addendum no. 01

project name: Lewis Central High School Rooftop Unit Replacement

project no: 25336

ED1.00

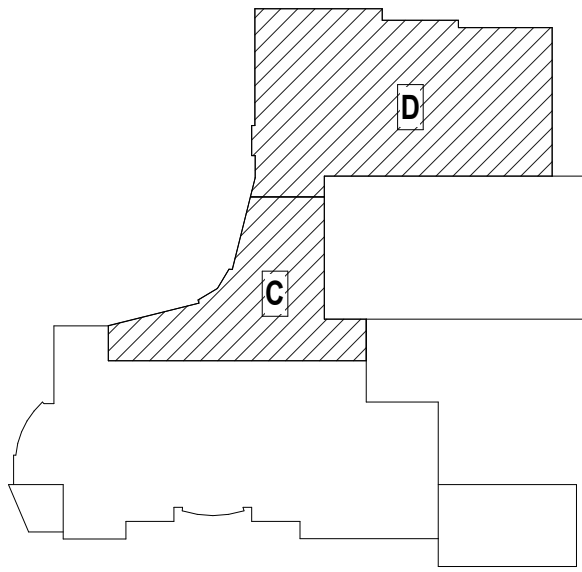
3. ED1.00 – FLOOR PLAN – ELECTRICAL DEMOLITION
 - a. Note for FA/speaker devices to be re-installed.
4. E1.01 – ROOF PLAN – ELECTRICAL
 - a. Show existing conduits on plans.

KEYNOTES
E002 REMOVE LIGHTING FIXTURE AND DISCARD. LEAVE ELECTRICAL WHIP IN PLACE. NEW FIXTURES WILL BE INSTALLED AS PART OF A DIFFERENT PROJECT.
E003 REMOVE DEVICE AND SET ASIDE FOR RE-USE. LEAVE FIRE ALARM WIRE OR SPEAKER CABLE IN PLACE. REINSTALL DEVICES AS PART OF THIS PROJECT. AFTER NEW CEILINGS ARE INSTALLED.

E1.01

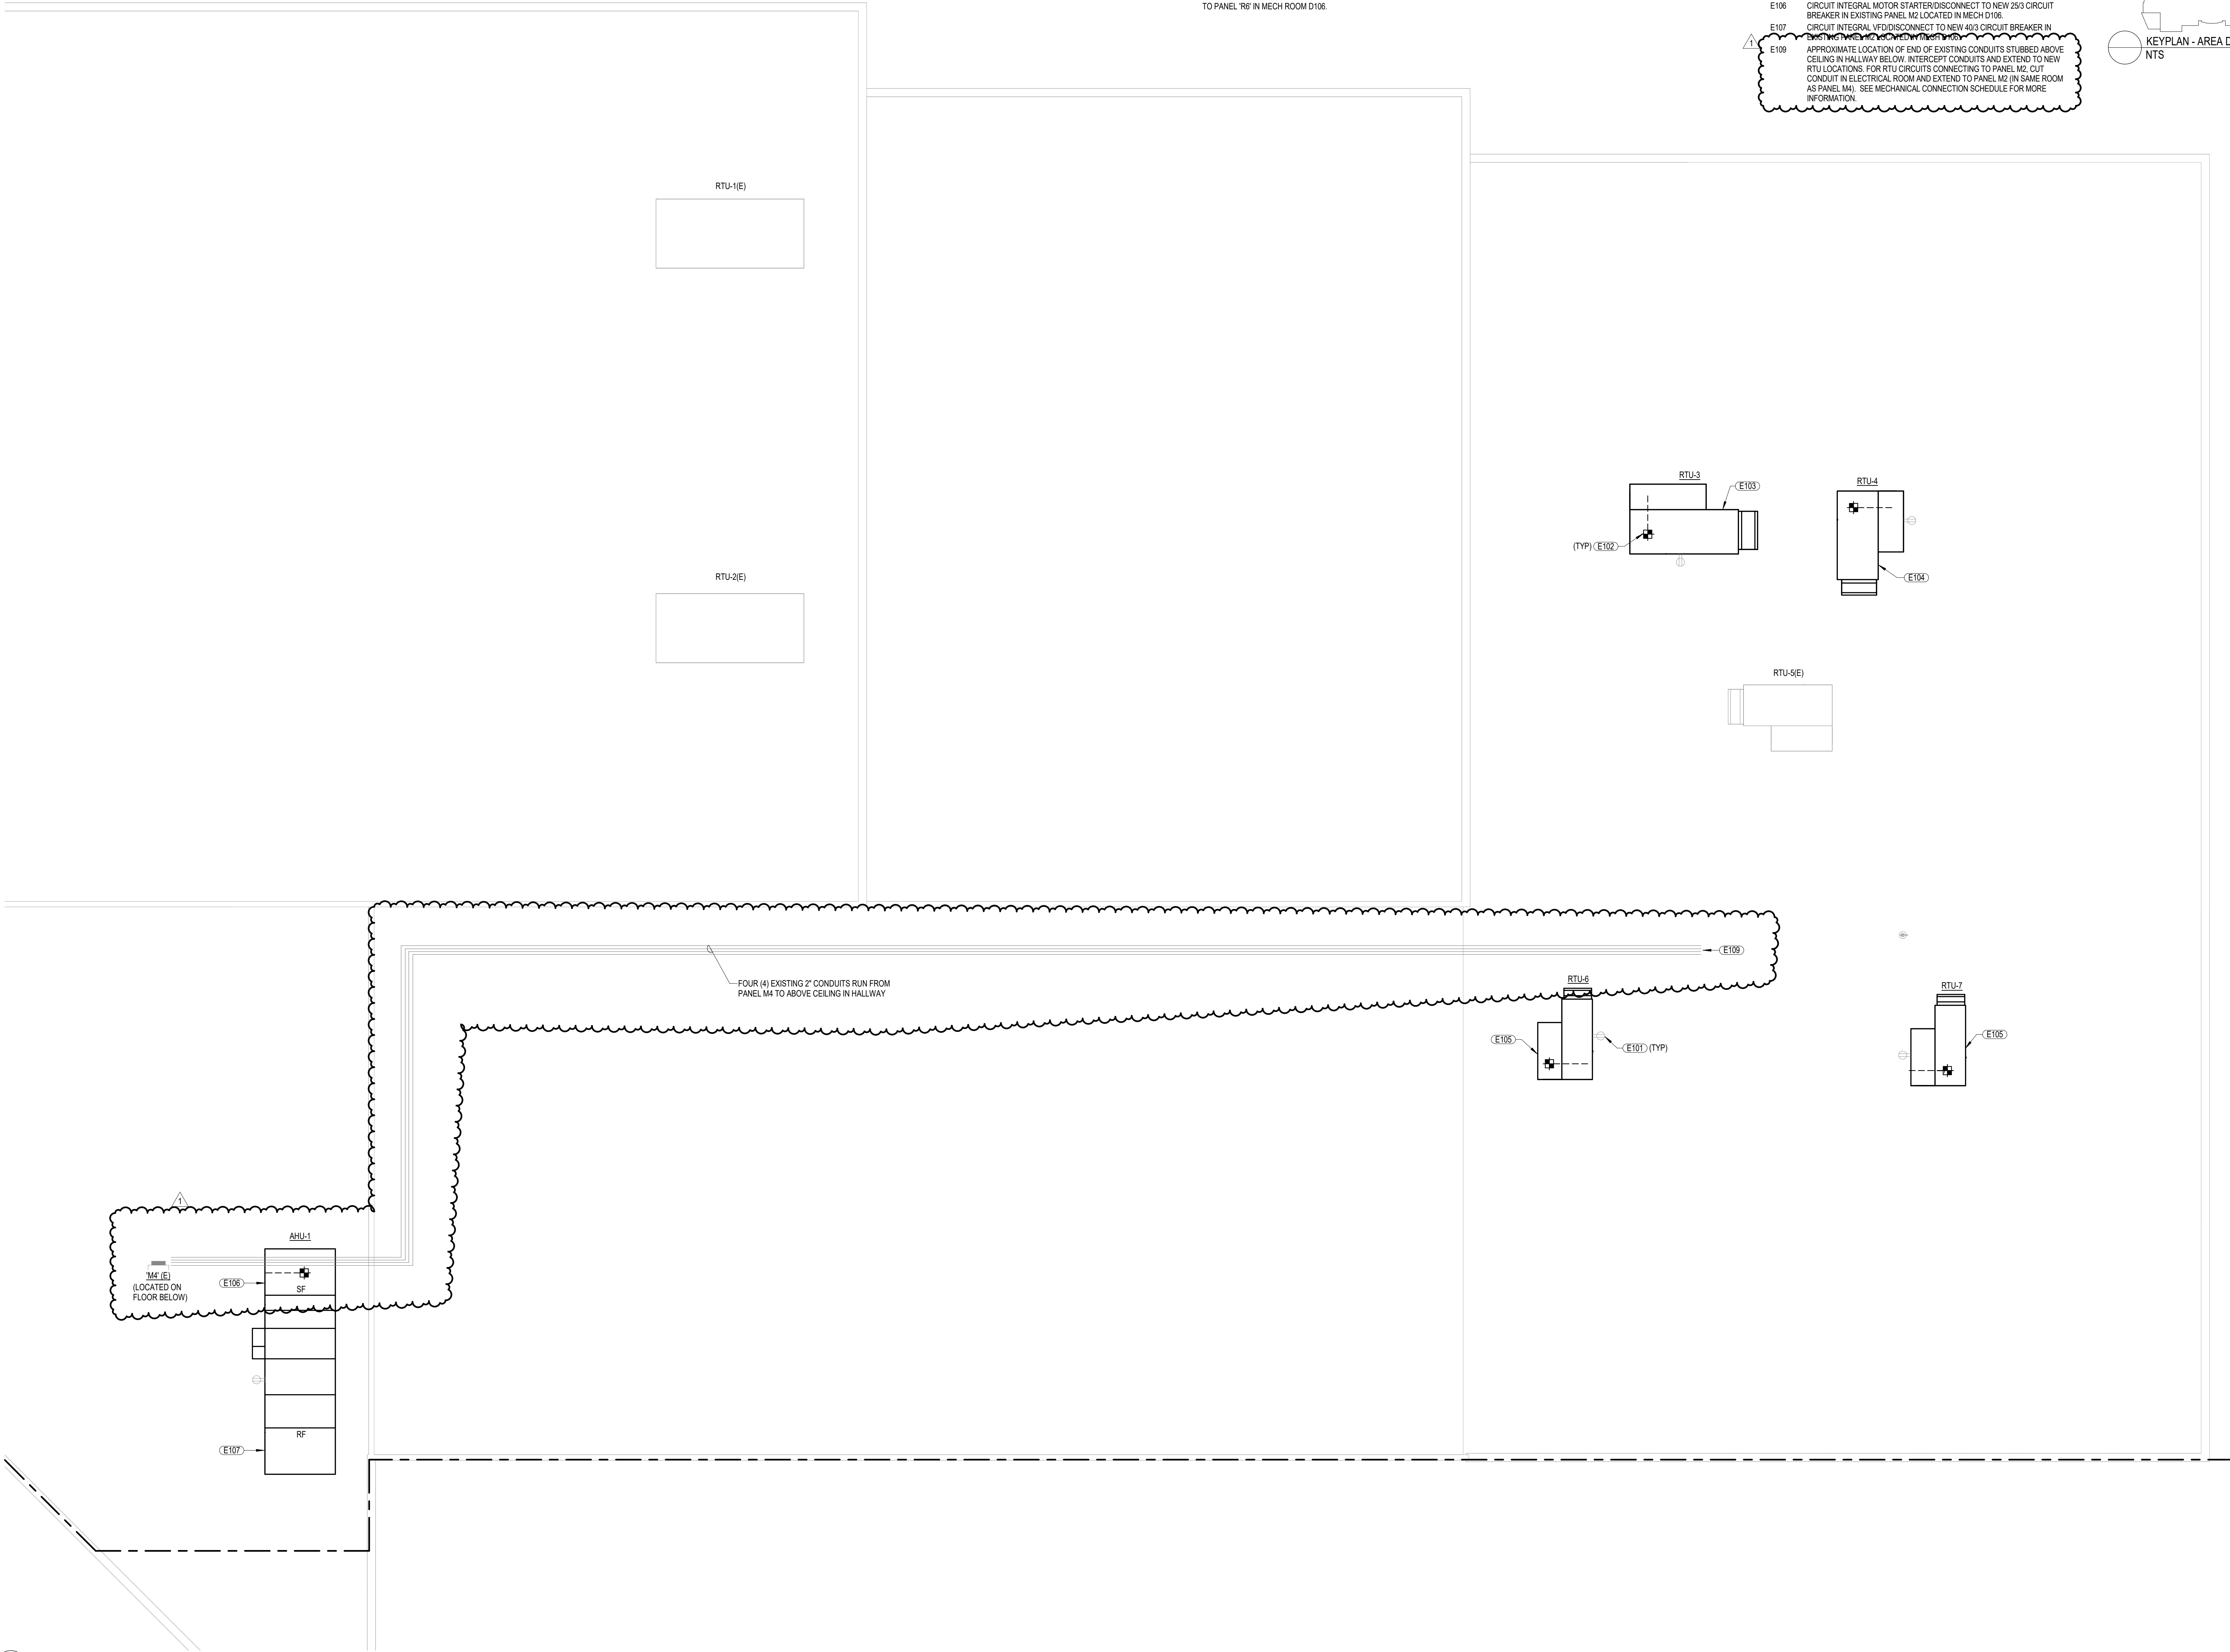
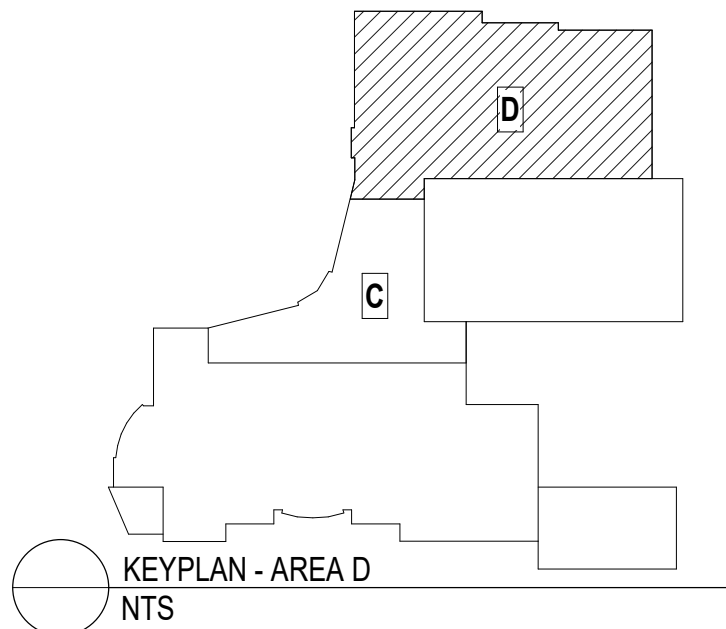
- E107 CIRCUIT INTEGRAL VFD/DISCONNECT TO NEW 403 CIRCUIT BREAKER IN EXISTING PANEL M2 LOCATED IN MECH D108.
- E109 APPROXIMATE LOCATION OF END OF EXISTING CONDUITS STUBBED ABOVE CEILING IN HALLWAY BELOW. INTERCEPT CONDUITS AND EXTEND TO NEW RTU LOCATIONS. FOR RTU CIRCUITS CONNECTING TO PANEL M2, CUT CONDUIT IN ELECTRICAL ROOM AND EXTEND TO PANEL M2 (IN SAME ROOM AS PANEL M4). SEE MECHANICAL CONNECTION SCHEDULE FOR MORE INFORMATION.
